Project	IEEE 802.16 Broadband Wireless Access Working Group < http://ieee802.org/16 >
Title	comment on Secure Roaming of Key Association for Fast Handover(C80216e-04_407)
Date Submitted	2005-01-14
Source(s)	[Feng Tian] [DongXin Lu] [Rui Li] Voice: [86-0755-26772017] [zte] Fax: [86-0755-26772004] [mailto:tian.feng2@zte.com.cn] [ZTE Plaza , Keji Road South , Hi-tech Industrial Park , Nanshan District , Shenzhen , P.R.China , 518057]
Re:	802.16e/D5
Abstract	comment on Secure Roaming of Key Association for Fast Handover(C80216e-04_407)
Purpose	comment on Secure Roaming of Key Association for Fast Handover(C80216e-04_407)
Notice	This document has been prepared to assist IEEE 802.16. It is offered as a basis for discussion and is not binding on the contributing individual(s) or organization(s). The material in this document is subject to change in form and content after further study. The contributor(s) reserve(s) the right to add, amend or withdraw material contained herein.

comment on Secure Roaming of Key Association for Fast Handover(C80216e-04_407)

Feng Tian , Dongxin Lu , Rui Li

2. Overview of Solution

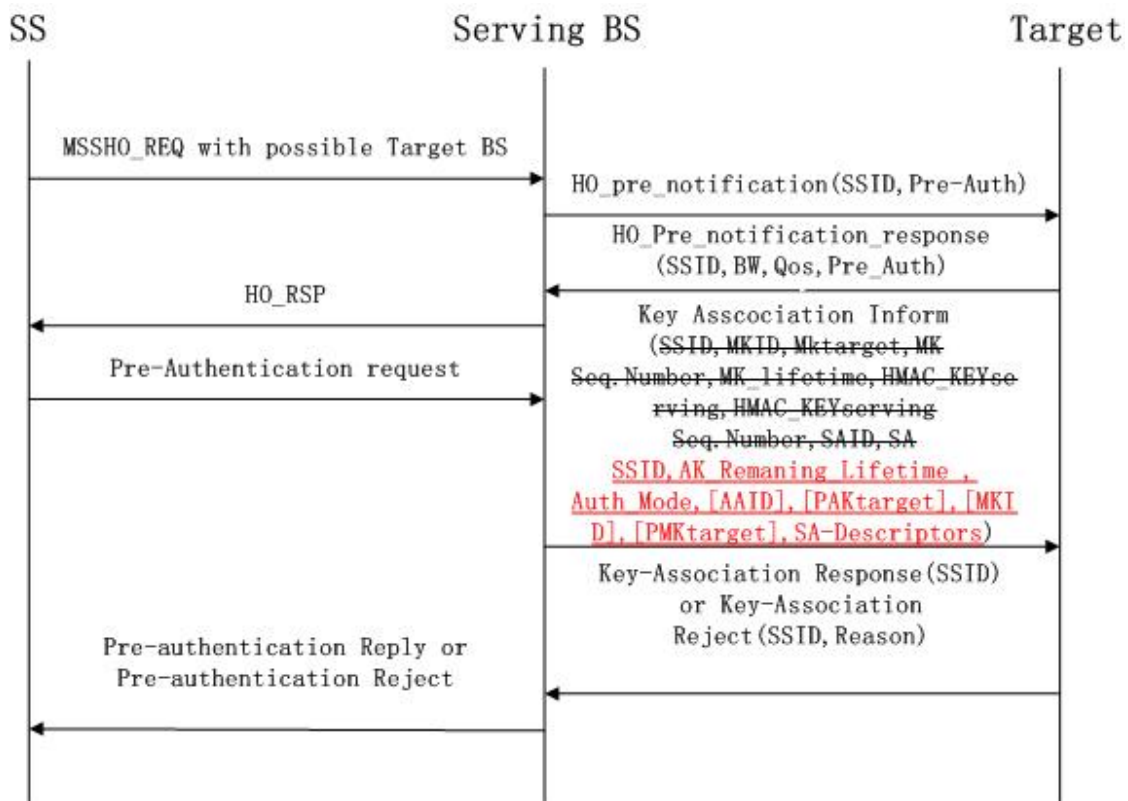
After handover procedure, the Key Association should be transferred from the serving BS to the target BS for fast handover. The serving BS should know whether the target BS supports a pre-authentication or not before Key Association is transferred. Therefore the serving BS sends HO-pre-notification including Pre_Auth field to the target BS to ask whether target BS supports pre-authentication or not while the MSS is attempting to perform network re-entry or handover. The target BS replies with the Pre_Auth field in HO-pre-notification response message. The security policy of the target BS may not allow pre-authentication.

After receiving a pre-authentication request from MSS, the serving BS transmits Key Association Inform message including ~~SSID, MK_{target}, MKID, MK sequence number, MK lifetime, HMAC_KEY_{serving}, HMAC_KEY_{serving} sequence number, SAID, and SA~~ **SSID , AK Remaning Lifetime , Auth Mode , PAK_{target} , PMK_{target} , AAID , MKID , SA-Descriptors** to the target BS. Through this procedure, the serving BS can prohibit that a compromised target BS acquires Key Association information. The target BS on receipt of a Key Association Inform message should reply with a Key Association Response message, or with a Key Association Reject message. After the exchange of Key Association messages, the serving BS transmits Pre-Authentication Reply message indicating that the chosen BS is populated with a PMK **and PAK** coupled to the identity of the requesting SS.
